Amendment No.1 of REF 14/2023: Child and Adolescent Mental Health Services (CAMHS) building - Nepean Hospital

Nepean Hospital / Western Region

To seek approval to amend the Review of Environmental Factors (REF) No.14/2023 by updating the Architectural Consultants engaged in relation to the design, development and construction of the CAMHS facility at Nepean Hospital and amend mitigation measure 8.3 in relation to design and treatment of the under-croft area and delete mitigation measure 23.1 relating to the engagement of a site auditor in respect to contamination.

Figure 1: North Elevation showing the approved materials and finishes including the proposed black metal mesh screen along the under-croft/lower level (courtesy: STH Architects).

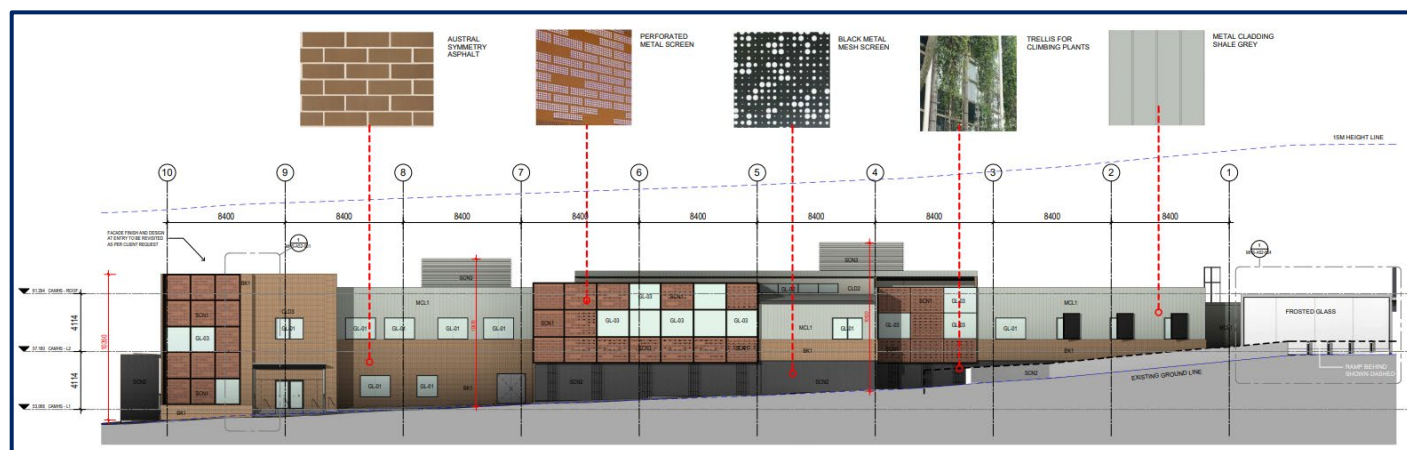
In respect to mitigation measure 8.3, this requires the design treatment and screening for the exposed under-croft section of the building to be “visually appealing”. The stamped REF plans show this area including a “black metal mesh screen” (refer to **Figure 1** below for the approved materials and finishes).

During the final design stage, some elements of the design have been modified and the materials proposed for the under-croft area have been altered to wire mesh screens or a black cyclone screening equivalent. It is therefore requested to amend the wording of mitigation measure 8.3 to allow for the new cost-efficient alternative screening. There is no change proposed to the requirement to landscape the front of the under-croft to “screen and soften the appearance of this area”. The landscaping should assist with screening this area and the proposed wire mesh or black cyclone screens, ensuring that the screen will not be visually dominating or exposed. Consequently, the intent of the measure should be satisfied.

- 8.3 The under-croft area of the CAMHS building shall be made inaccessible (apart for access for maintenance) ~~and shall include louvred screens or the like which will be visually appealing~~. The area immediately in front of the under-croft shall be landscaped to screen and soften the appearance of this area.
